Regional Transportation Plan: Removal of proposed Minor Collector as the future extension of Seminole Dr

10/16/2023

Amendment Application

Stub-Outs at Applicant Property

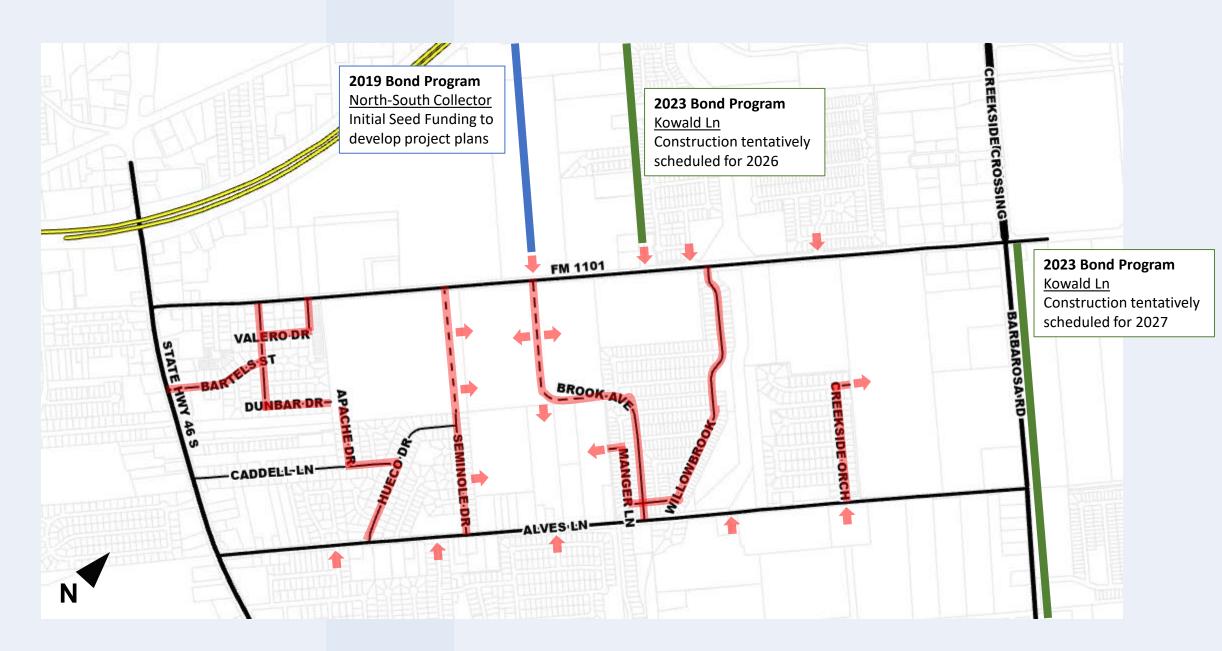
- Traditional single and two-family developments include street stub-outs to continue the public street network
- Transition to multifamily, private rental, and county areas (no zoning) <u>may</u> discontinue the street network
- Only public street connection and location requirement is the thoroughfare plan

Seminole Drive: Existing

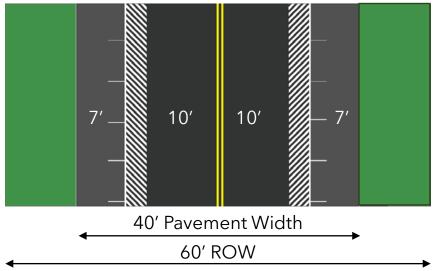
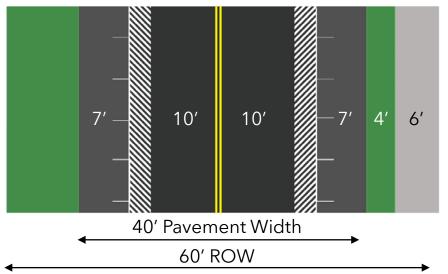
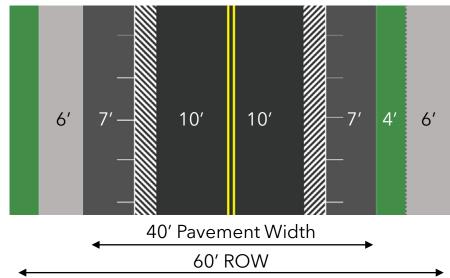
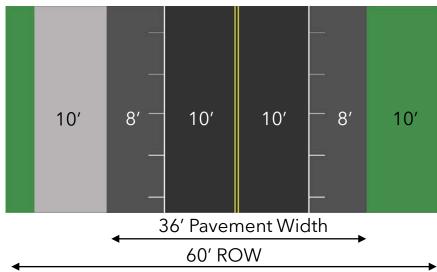
- No or minimal impact on existing driveway access and on-street parking
- Do not support raised intersections and mini traffic circle
- Request construction of other thoroughfares Brook Ave and North-South Collector

- 50' ROW (30' Pavement) for Minor Collectors
- 50' ROW (30' Pavement) for Local Roads
- 80' ROW widened near future major connections
- 10' Shared Use Path from Alves Lane to FM1101 (Option 4)
 - Alternatively, 6' sidewalk with space for buffer
- Mini-Roundabouts:
 - o 80'-90' Inscribed Circe
 - o Mountable Center Island
 - o No truck thru-traffic
 - o 20' Circulating Roadway
 - o 15° Angle of Entrance Deflection
